ADDENDUM NO. 1

RFQ CCC-078

**Administration Building Renovation
Compton Community College District**

tBP Project. No. 20987.00

10. Revised SHEET A8-1 INTERIOR ELEVATIONS

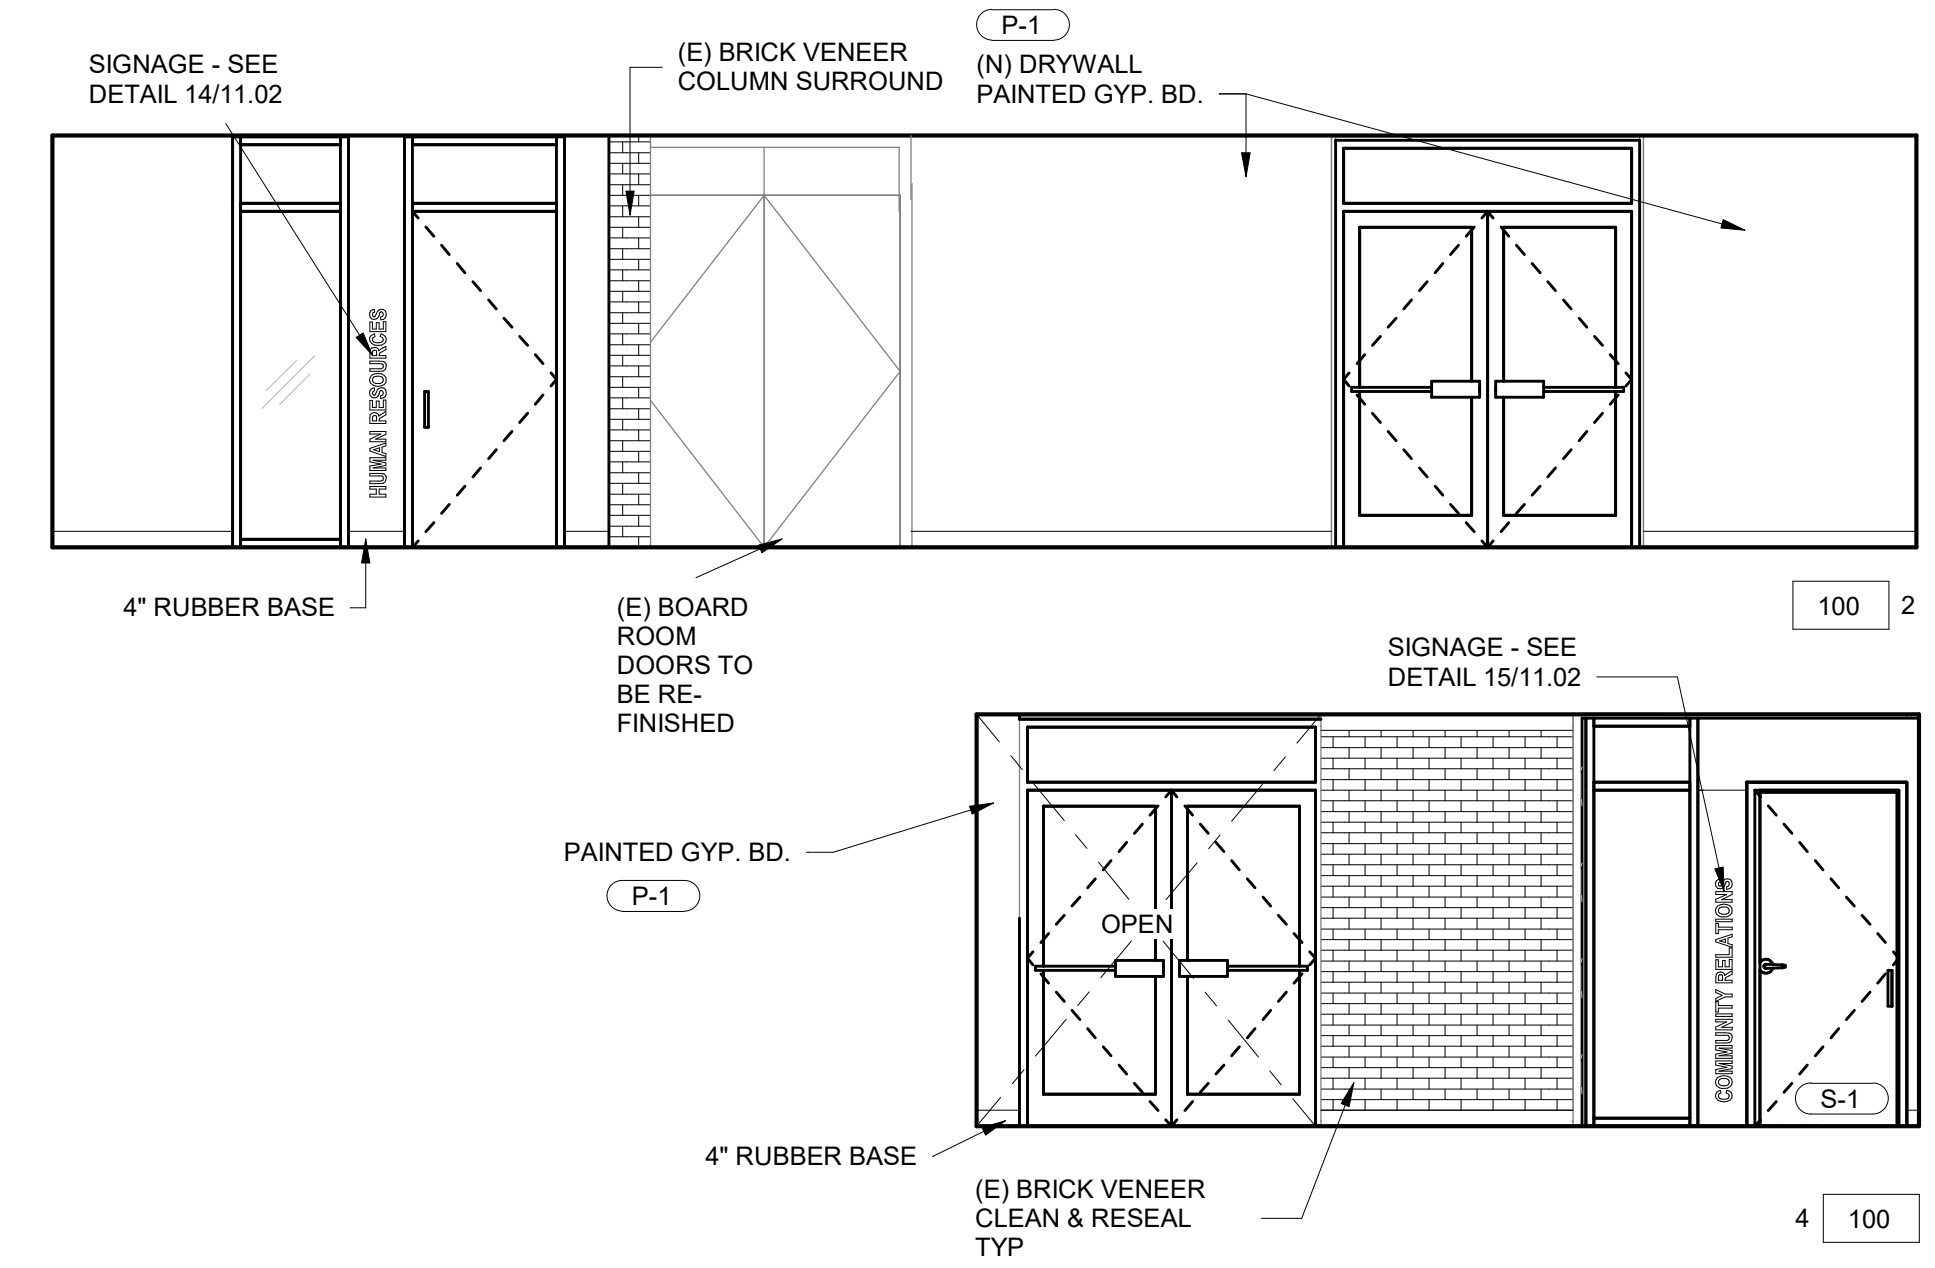
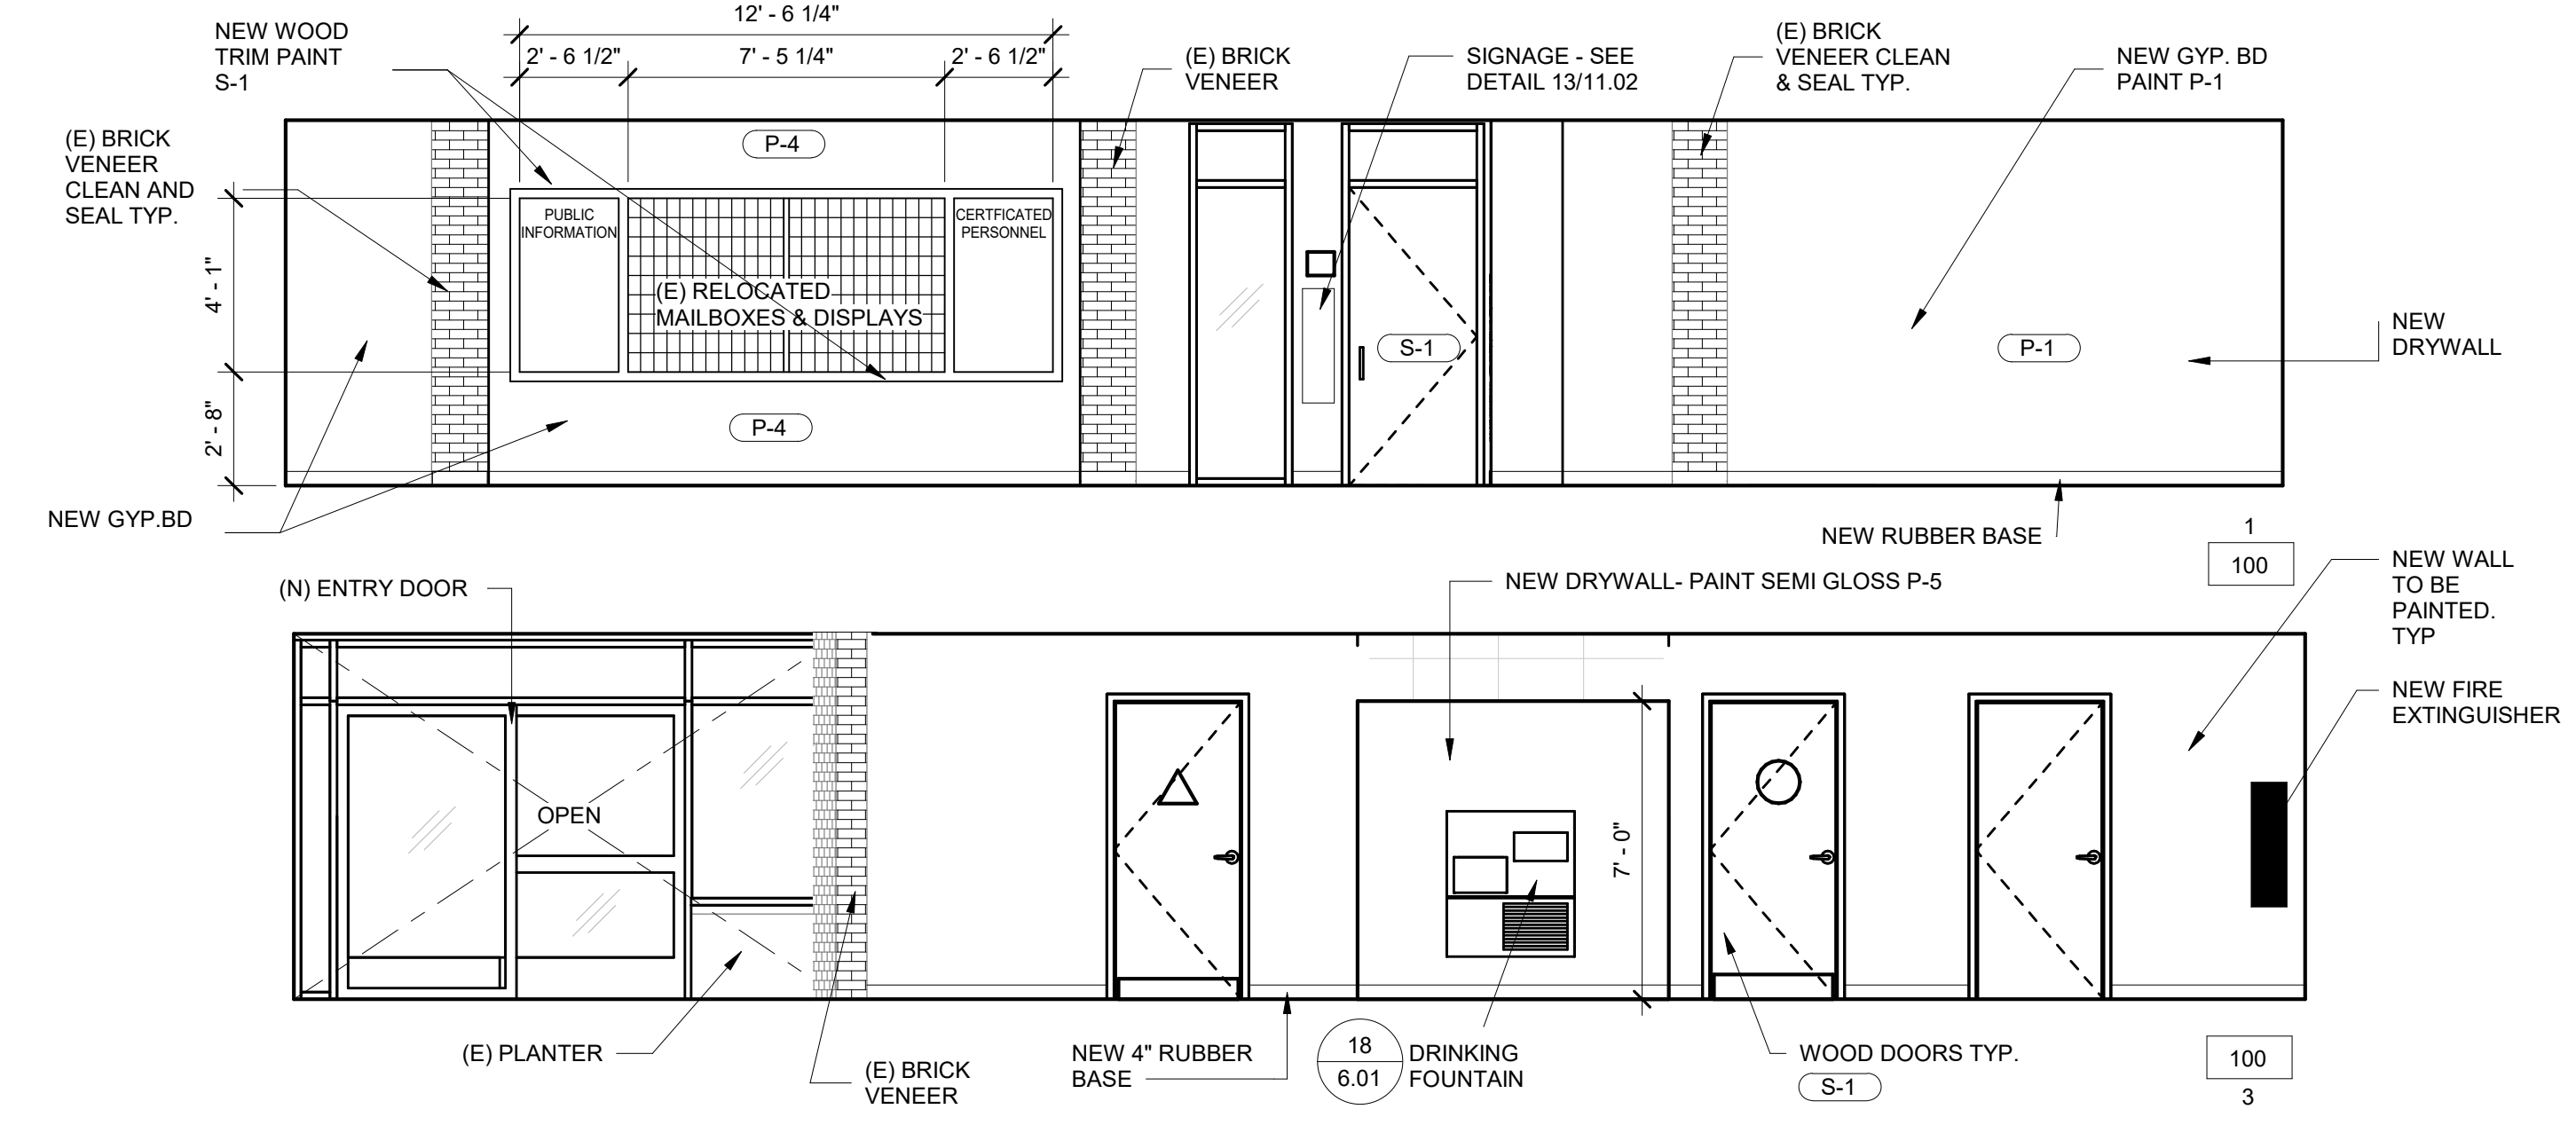
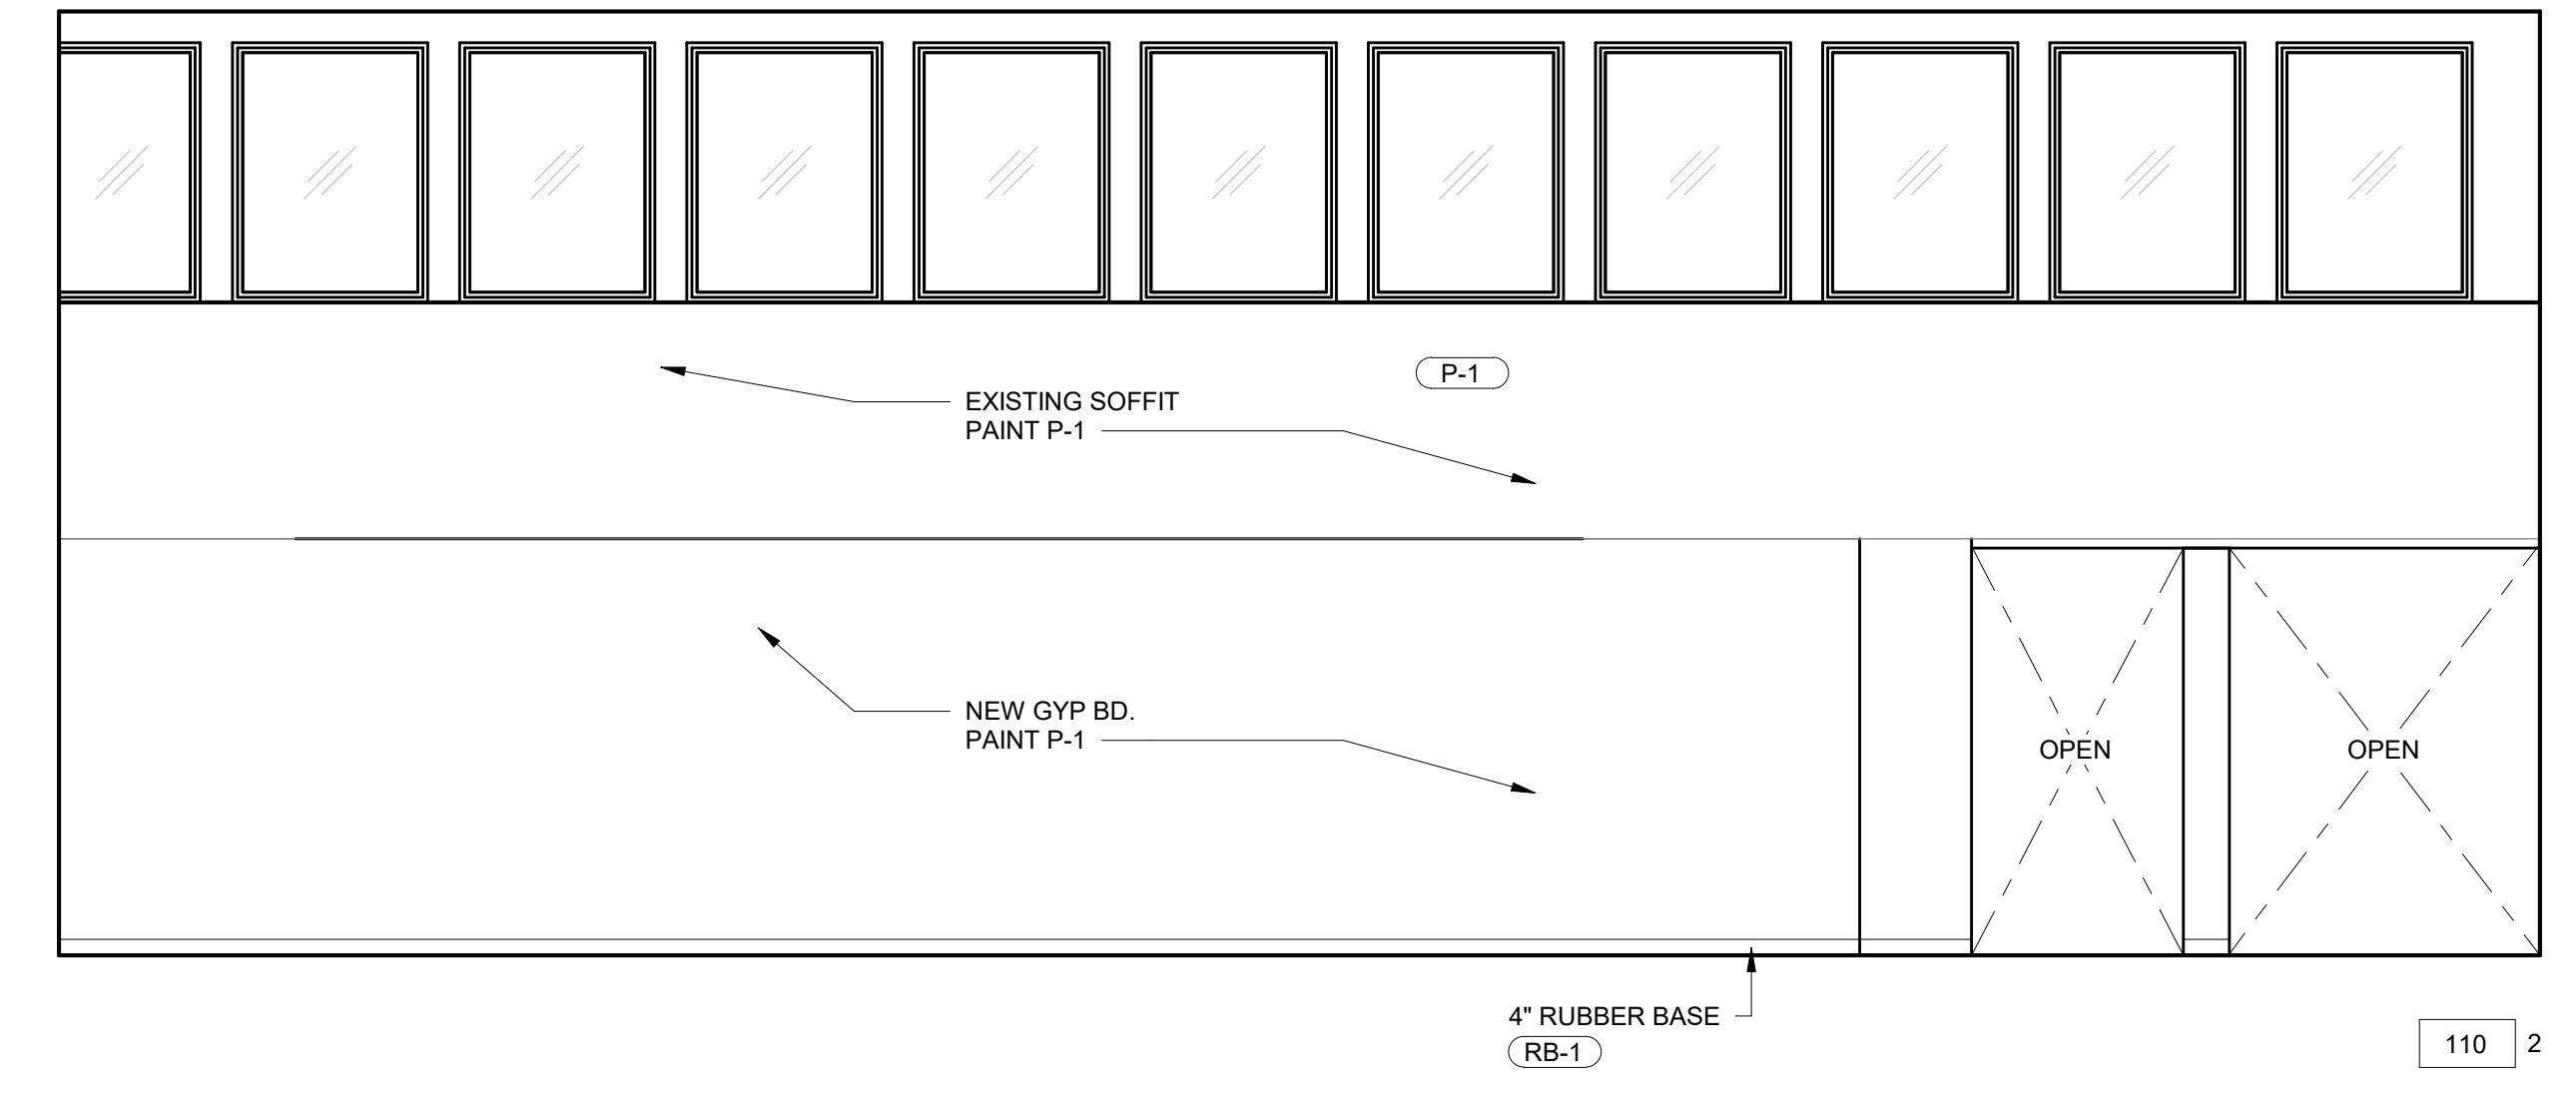
- b. Added finishes notes.
 - c. Removed crown molding and wood base and refinishing of wood paneling at Lobby.
 - d. Added soffit for duct at Open Office Room 110
See attached revised Full size sheet identifying revisions included as part of this addendum.
